**Response to U.S. EPR Design Certification Application RAI No. 413, Supplement 3,
Questions 07.08-24, 07.08-30, 07.08-31, 07.08-36, 07.08-37, 07.08-40, and 07.08-41**

Request for Additional Information No. 413(4772), Revision 1, Supplement 3

U. S. EPR Standard Design Certification

SRP Section: 07.08 - Diverse Instrumentation and Control Systems

Figure 07.08-24-2 — SG-4 NR Level - D3 MSIV Closure

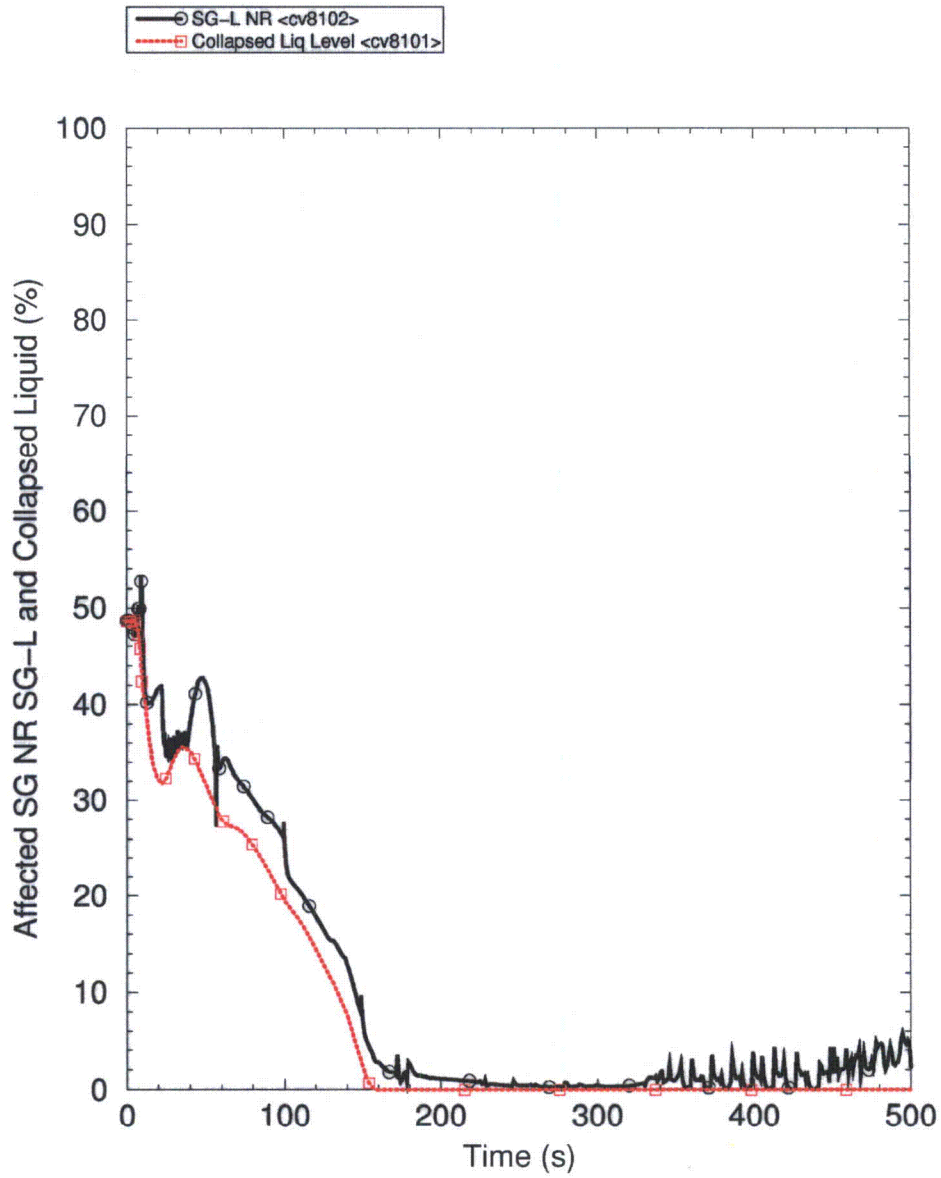
Provide additional information to support the reliability of the predicted DAS trip actuation on Low SG Level, including the following:

- a. A description of the S-RELAP5 SG level model and the SG narrow range level instrumentation model, including validation basis, and
- b. An evaluation of the decalibration effects of the MSIV closure on the narrow range instrumentation and how decalibration is treated in the simulation model.

The engineering analysis of the Inadvertent MSIV Closure event presented in Section A.3.3.2 of ANP-10304 Rev 1 shows that a DAS reactor trip actuation occurs on Low SG Level, terminating the secondary system pressure excursion at about 1640 psia, or 100 psia below the D3 analysis criterion of 120 percent of secondary system design pressure ($1.20 \times 1450 \text{ psia} = 1740 \text{ psia}$). The Inadvertent Closure of MSIV event analyzed in the FSAR results in PS reactor trip actuation (at approximately 6 seconds) on High SG Pressure, which is not available through DAS. Therefore, an explicit D3 engineering analysis is provided in ANP-10304 Rev 1 Section A.3.3.2 for the Inadvertent Closure of MSIV event. The D3 analysis shows that at approximately 130 seconds DAS provides a reactor trip actuation on Low SG Level. The pressure in the affected SG reaches approximately 1640 psia, or 113% of the secondary system design pressure (design pressure is 1450 psia, per FSAR Table 10.3-1). Considering the rate of change of the SG pressure excursion and its calculated peak value relative to the D3 analysis criterion (1640 psia peak SG pressure versus 1740 psia criterion), additional information on the SG level model and the DAS Low SG Level trip function is required in order for staff to complete its review of the Inadvertent Closure of MSIV D3 analysis.

Figure 07.08-24-2 shows the NR level response for the MSIV closure event for end of cycle (EOC) conditions. The reactor trip on diverse actuation system (DAS) low SG level at 15 percent NR level occurs at 133 seconds after MSIV closure. The plots show that if the collapsed liquid level scheme had been used for DAS input instead of the differential pressure algorithm the reactor trip (see Figure 07.08-24-3) on low level would have occurred 5 to 10 seconds earlier.

Figure 07.08-31-1 — Peak Fuel Rod Axial Shapes from NEMO-K and Best Estimate Models

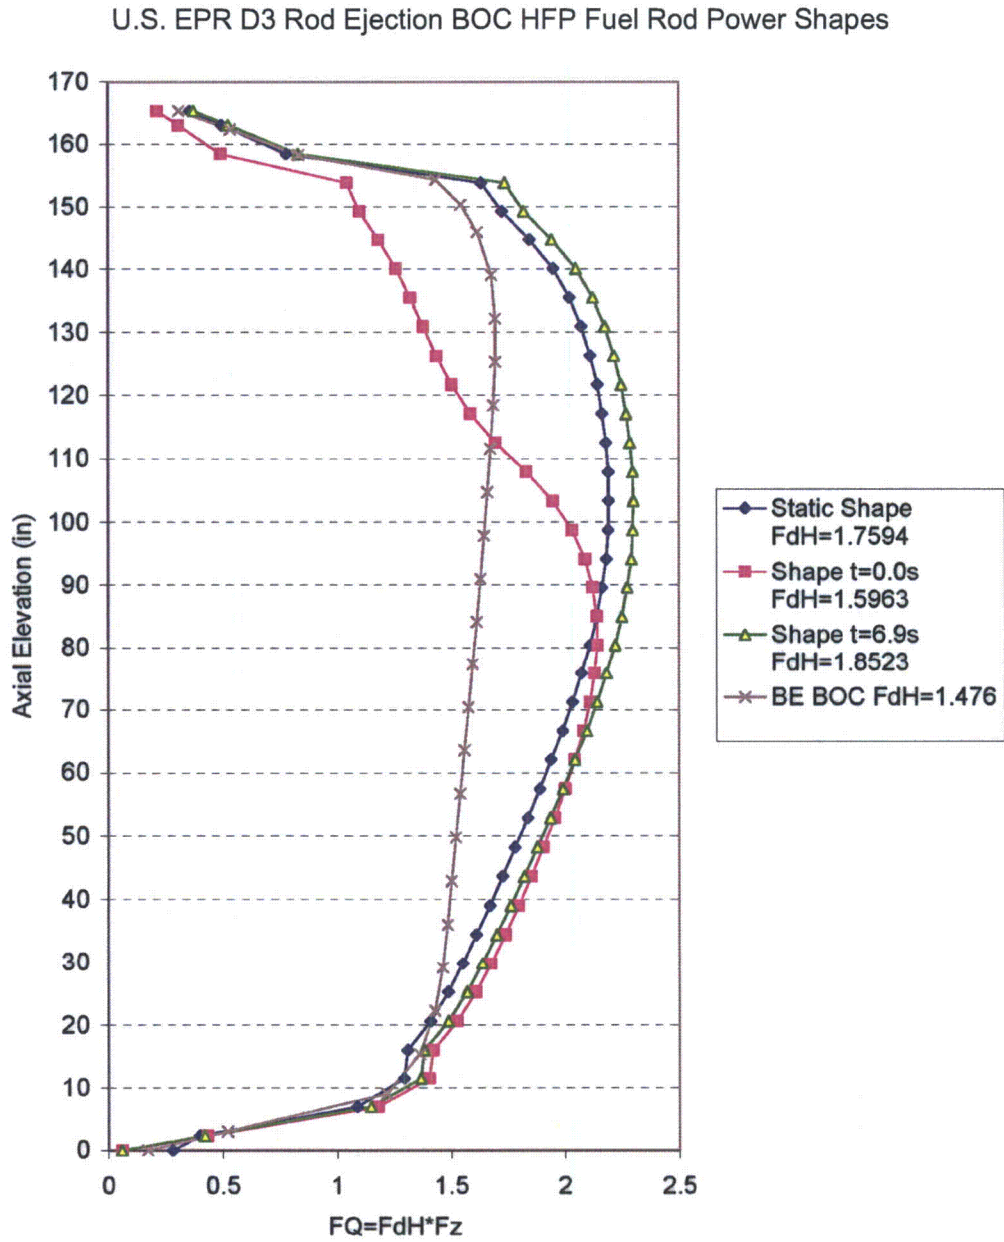
Provide an explanation of difference in the DNBR transient between the no-rupture and with-rupture RCCA Ejection cases described in Section A.3.5.6, including:

- a. Identification of any differences in analysis assumptions (e.g., initial conditions, reactivity parameters) that affect the transient,
- b. A comparison of the key reactor parameters affecting DNBR, e.g., power level, peaking factors, reactor pressure, coolant temperatures, core flow.

The applicant reports that the RCCA Ejection event, assuming no vessel rupture, does not exceed the DNBR SAFDL, whereas for the rupture cases the DNBR decreases below the SAFDL. The staff is not able to identify design descriptions that would permit sufficient understanding in order to complete the safety evaluation.

The sequence of events for each break size case is provided in Tables 07.08-31-1, 07.08-31-2, and 07.08-31-3. The axial power shapes along with their associated radial peaking factors for the peak fuel rod are provided in Figure 07.08-31-1. The transient shapes are shown for key time points of the transient and are a subset of the full data set from the 3D kinetics calculation. A comparison of the responses for the total core power, the core exit pressure, the core inlet temperature, the minimum departure from nucleate boiling ratio (MDNBR)/specified acceptable fuel design limit (SAFDL), the peak fuel and cladding temperatures, and the peak average enthalpy rise in the fuel are provided in Figures 07.08-31-2 through 07.08-31-6. The information is shown for each case out beyond the time of the MDNBR point. The information shown for each case is beyond the time of the minimum DNBR point. The time ranges presented are from 200 seconds for the no break case to a few seconds after reactor trip for the break cases. The information in the figures allows the following observations to be made:
